PIC16(L)F1826/1827 Family Silicon Errata and Data Sheet Clarification

The PIC16(L)F1826/1827 family devices that you have received conform functionally to the current Device Data Sheet (DS41391D), except for the anomalies described in this document.

The following typographic corrections and clarifications are to be noted for the latest version of the device data sheet (DS41391D):

FIGURE 1: INSTRUCTION CYCLE DELAY CALCULATION EXAMPLE

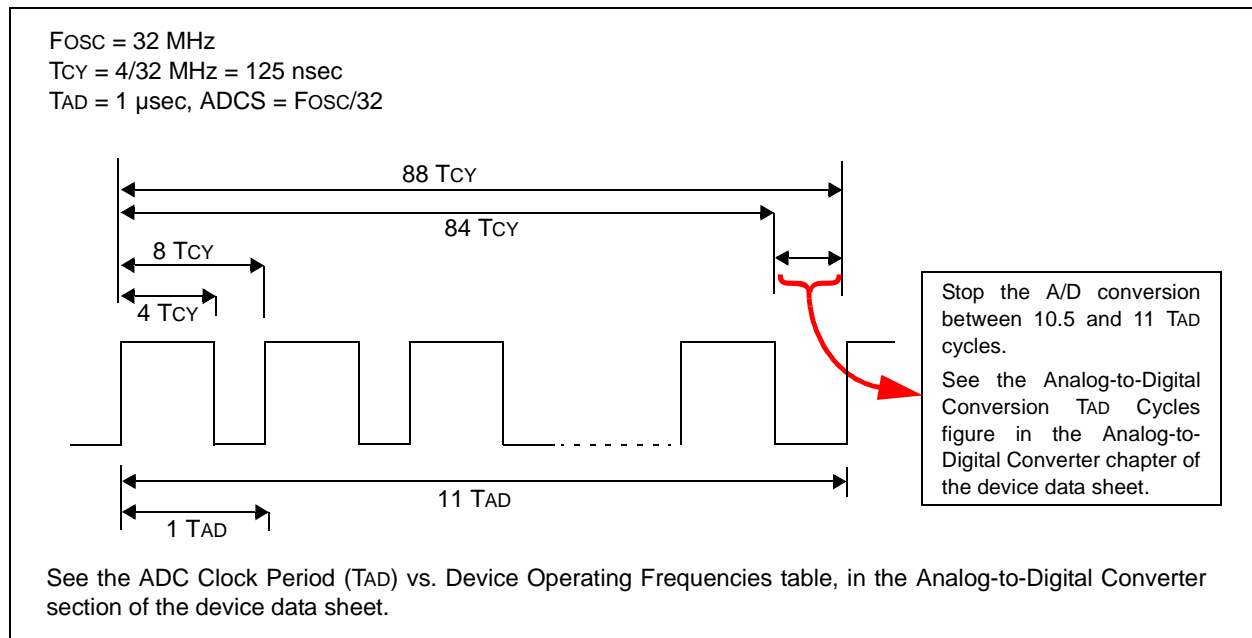
An ADC conversion may not complete under these conditions:

1. When F_{OSC} is greater than 8 MHz and it is the clock source used for the ADC converter.
2. The ADC is operating from its dedicated internal FRC oscillator and the device is not in Sleep mode (any F_{OSC} frequency).

When this occurs, the ADC Interrupt Flag (ADIF) does not get set, the $\overline{GO/DONE}$ bit does not get cleared, and the conversion result does not get loaded into the ADRESH and ADRESL result registers.

Method 3: This method is provided if the application cannot use Sleep mode and requires continuous operation at frequencies above 8 MHz. This method requires early termination of an ADC conversion. Provide a fixed time delay in software to stop the A-to-D conversion manually, after all 10 bits are converted, but before the conversion would complete automatically. The conversion is stopped by clearing the $\overline{GO/DONE}$ bit in software. The $\overline{GO/DONE}$ bit must be cleared during the last $\frac{1}{2}$ TAD cycle, before the conversion would have completed automatically. Refer to [Figure 1](#) for details.

In [Figure 1](#), 88 instruction cycles (T_{CY}) will be required to complete the full conversion. Each TAD cycle consists of 8 T_{CY} periods. A fixed delay is provided to stop the A/D conversion after 86 instruction cycles and terminate the conversion at the correct time as shown in the figure above.

Note: The exact delay time will depend on the TAD divisor (ADCS) selection. The Tcy counts shown in the timing diagram above apply to this example only. Refer to [Table 3](#) for the required delay counts for other configurations.
